WATER PERMIT NO. 8951-3

**RECOMMENDATION OF ACTING CHIEF ENGINEER FOR WATER PERMIT
APPLICATION NO. 8951-3, Tyson Nuhsbaumer**

Report to the Chief Engineer
Water Permit Application Nos. 8949-3 & 8950-3

Tom Nuhsbaumer
& 8951-3

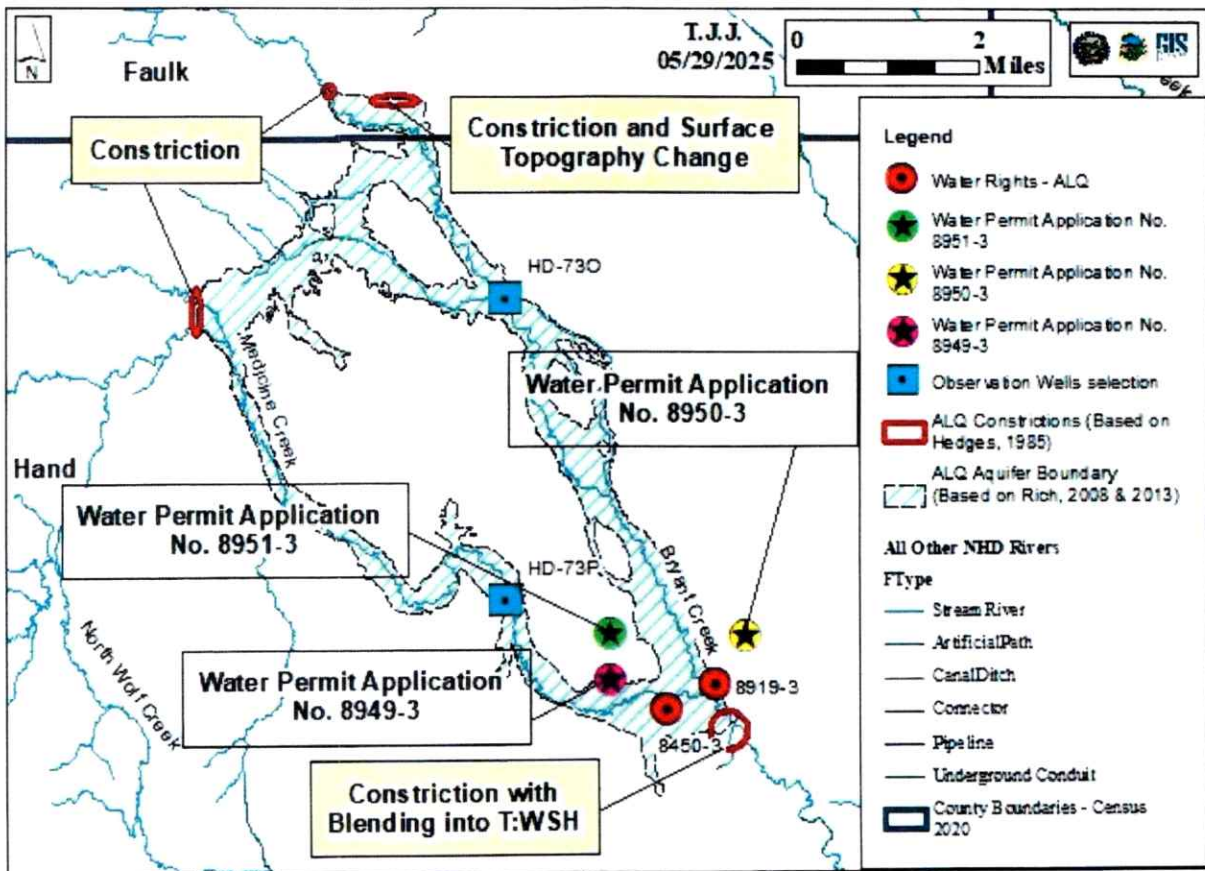
At a depth of 60 feet for each well, the wells should not be deep enough to connect to a lower aquifer. Some of the proposed well locations are located outside of the Quaternary aged Alluvium aquifer boundary as drawn (see Figure 1). However, the boundary is an approximation, and the proposed well locations are close enough and at a similar enough elevation that aquifer material found at the proposed depth can reasonably be assumed as part of the aquifer Quaternary aged Alluvium aquifer shown in Figure 1.

The areal extent of the Quaternary aged Alluvium aquifer shown in Figure 1 is approximately 5,100 acres (240 acres in Faulk County & 4,877 acres in Hand County) (modified from: Rich, 2013 & 2008). The Quaternary-aged alluvium is primarily comprised of clay and silt with some sand and gravel. In general, the direction of water movement in alluvium is the same as Medicine Creek and Bryant Creek. The geology of a water well completion report near the proposed well locations for applications Nos. 8949-3 & 8951-3 (half a mile west & one mile south respectively) is described as: yellow clay till 0-26 feet, blue clay 26-35 feet, medium sand 35-42 feet, coarse gravel 42-44 feet, blue clay till 44-67 feet, coarse sand & gravel 67-69 feet, shale 69-80 feet below ground surface (Water Rights, 2025c). The proposed locations of the wells are along Bryant Creek, the static water level should be similar to the level of the creek, at or near land surface. The geology of the water well completion report closest to proposed well locations for application No. 8950-3 (0.6 miles northwest) is described as: topsoil, sand & gravel 0-20 feet,

The diversion points for water permit application Nos. 8950-3 & 8951-3 are located outside of the quaternary aged alluvium aquifer boundary. However, the aquifer may extend past the proposed boundary. Since the diversion points for both applications are less than a mile from the boundary, they should be close enough to withdraw from the Quaternary aged Alluvium aquifer if aquifer material is present at the site at the proposed well depths.

As shown in Figure 1, there are two water rights/permits listed as authorized to withdraw water from this portion of the Quaternary aged Alluvium aquifer (Water Rights, 2025b). Water Right No. 8450-3 authorizes four wells that are located 0.7 to 1 mile southeast of water permit application Nos. 8949-3 & 8951-3 proposed well locations (Water Rights, 2025b). Water Right No. 8919-3 authorizes four wells that are located 0.6 miles southwest of water permit application No. 8950-3 proposed location (Water Rights, 2025b). However, Water Right Nos. 8450-3 & 8919-3 are held by Tom Nuhsbaumer, so it is likely these proposed wells will be managed to prevent potential impairment of the existing water rights.

Figure 2. A graph showing the elevation of water levels in observation wells HD-73O and HD-73P (Water Rights, 2025b)

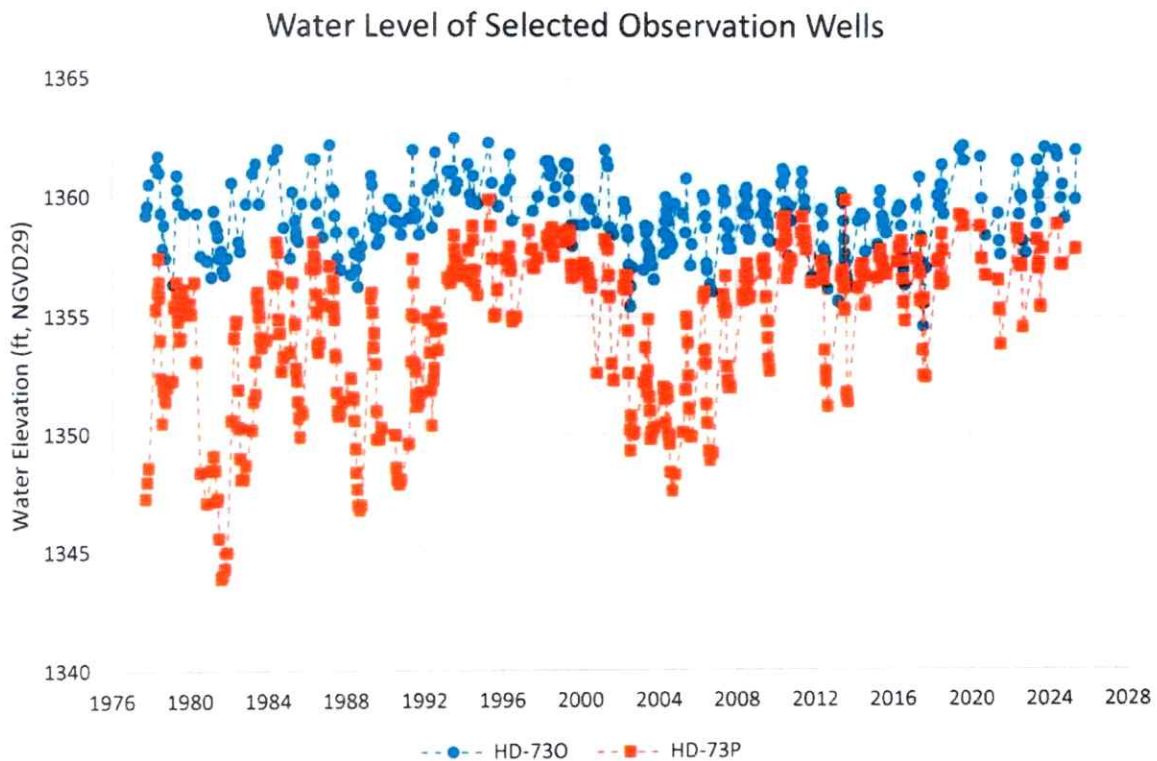
Figure 2 shows the observation wells display generally stable water levels. The hydrographs for this portion of the Quaternary aged Alluvium aquifer indicate that the aquifer responds well to climatic conditions because water levels are rising during wetter periods (early spring snowmelt and precipitation) and declining to a stable water level during drier periods. Additionally, the water levels in the observation wells display that the amount of recharge to and natural discharge from the aquifer greatly exceeds withdrawal with the aquifer returning to pre-withdrawal

conditions seasonally as is common with this type of aquifer when recharge and natural discharge greatly exceed recharge. Aquifer recovery indicates that climatic conditions and therefore, the effects of recharge to and natural discharges from the aquifer govern the long-term fluctuations of waters levels in the aquifer rather than the impacts of withdrawal from this portion of the Quaternary aged Alluvium aquifer.
